10.0 Steam and Power Conversion System

The information in this section of the reference ABWR DCD, including all subsections, tables and figures, is incorporated by reference with the following departures and supplements.

Figure 10.1-1 Reference Steam and Power Conversion System

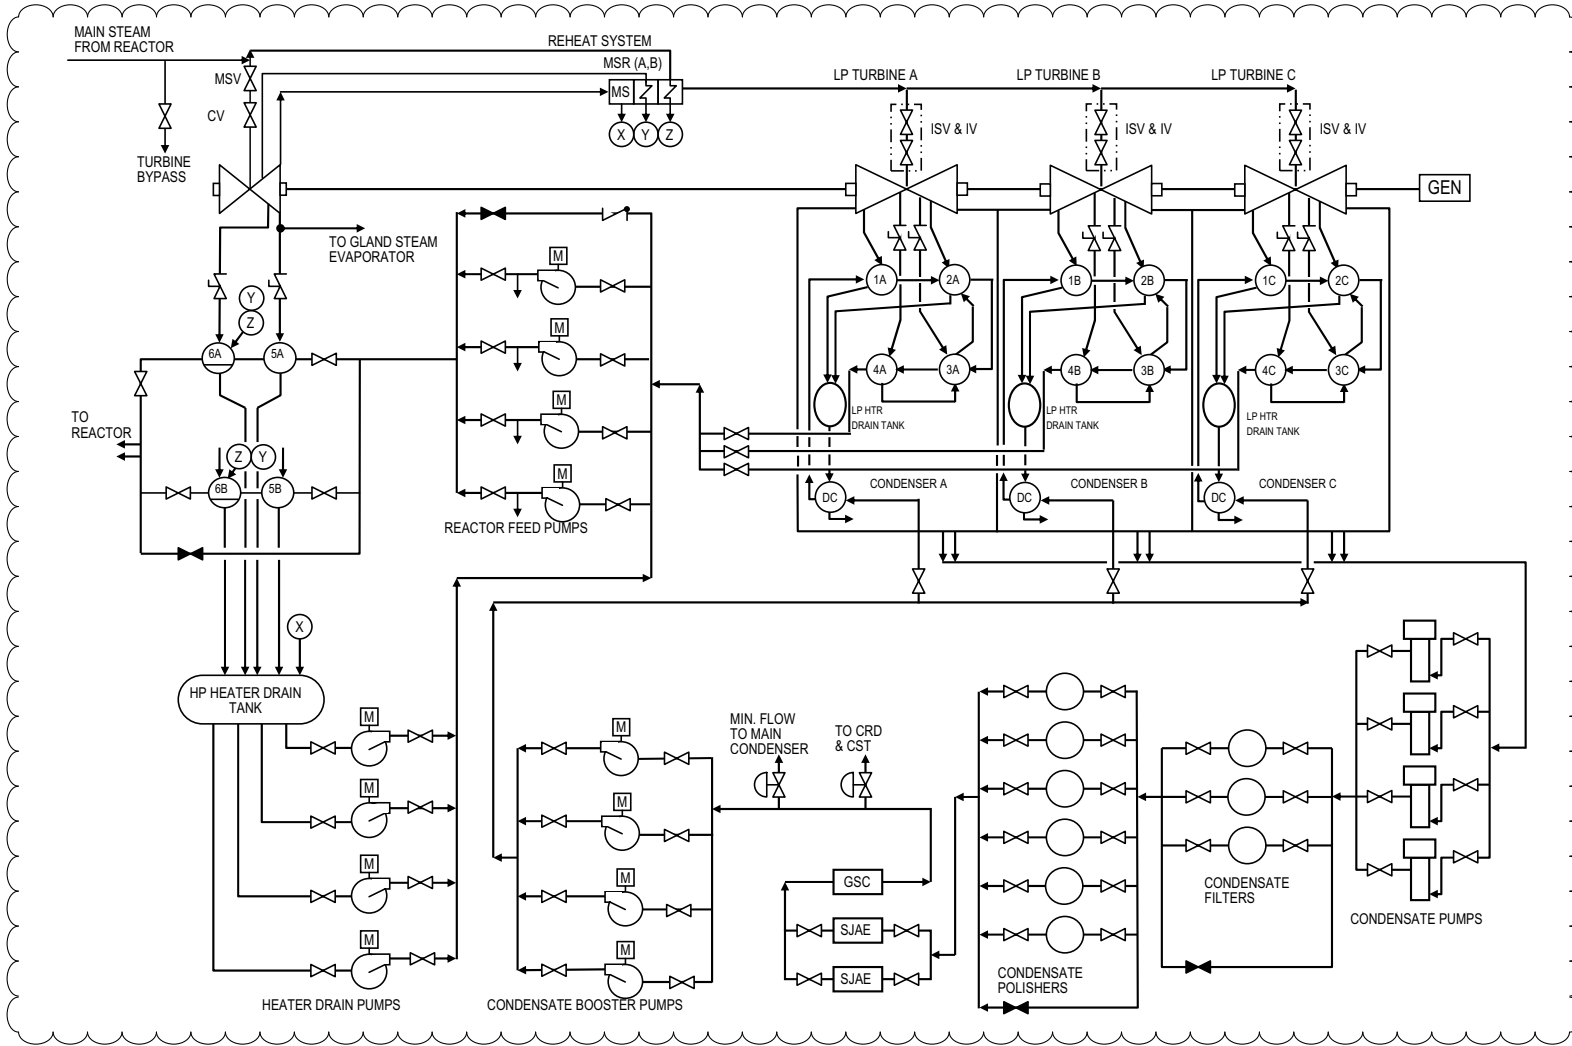
STP DEP 9.2-3 (Figure 10.1-1)

STP DEP 10.1-2 (Figure 10.1-1)

STP DEP 10.2-1 (Table 10.1-1, Figure 10.1-1)
